## **Project Update: OYSTER BAY REGIONAL SHORELINE Land Use Plan Amendment (2012)**

## **Summary of Discussion from Public Meeting #1**

**Date / Time:** July 18, 2012; 6:30 - 8:30 p.m.

**Note:** This concept map was developed to facilitate planning and discussion of the Oyster Bay LUPA for the July 18, 2012 LUPA public meeting.

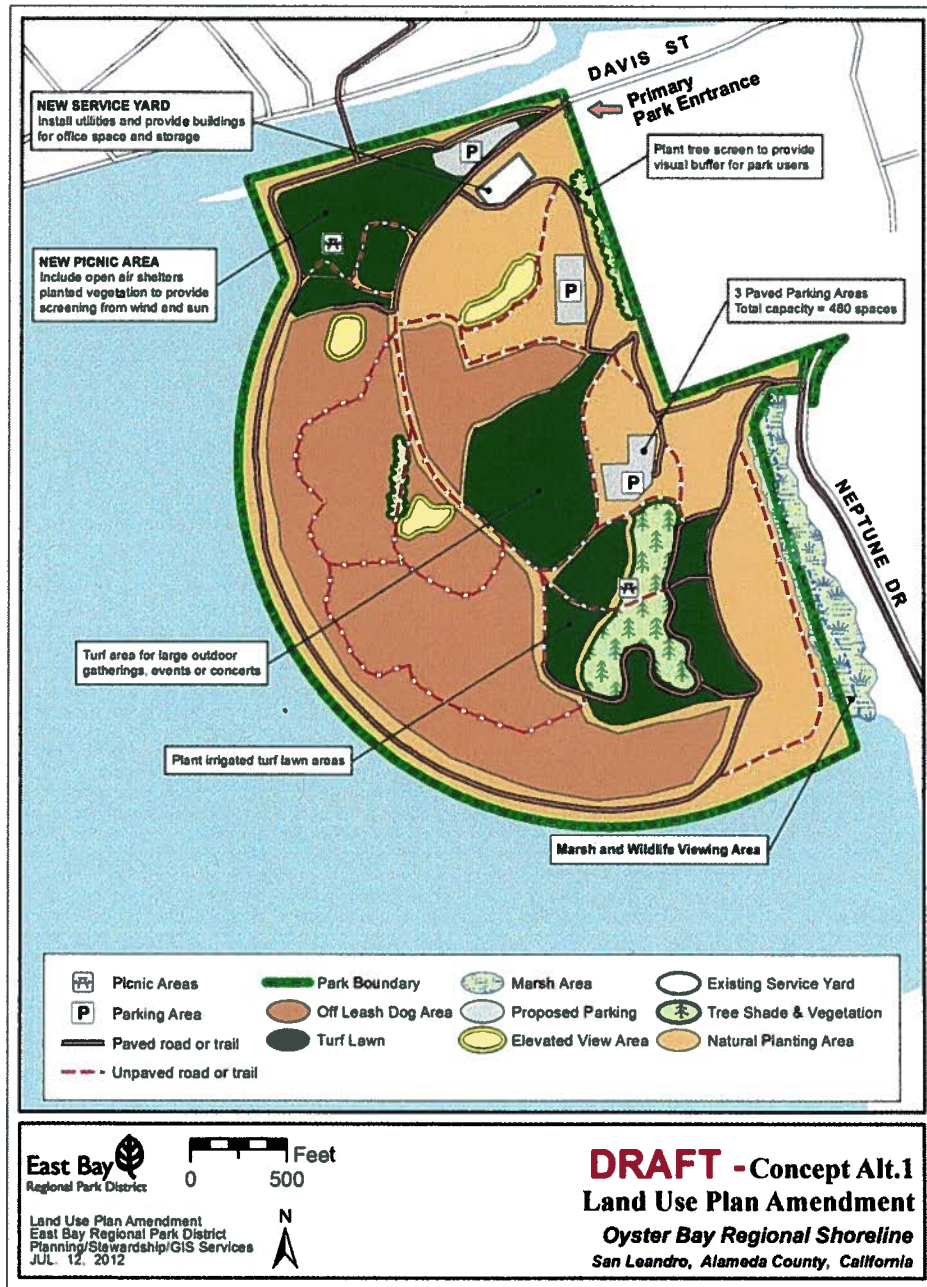
Meeting attendees voiced their general support for the amount of parkland that remains designated for off-leash dog walking. (See attached map)

- Turf can be difficult to maintain.
- Why is the central open turfed meadow area located where it is? (See map)

**(EBRPD) The LUPA is intended to improve the design, operation and future character of the park. The preliminary scoping process for this LUPA has already reduced the amount of irrigated turf that was originally envisioned for Oyster Bay. However, many people enjoy being able to sit in or run around on open grass covered areas. The park’s central area topography is bowl-shaped and would assist in shielding the open meadow from much of the wind blowing in from the San Francisco Bay. The expansive area and its central location could also support mid-to-large sized outdoor events.**
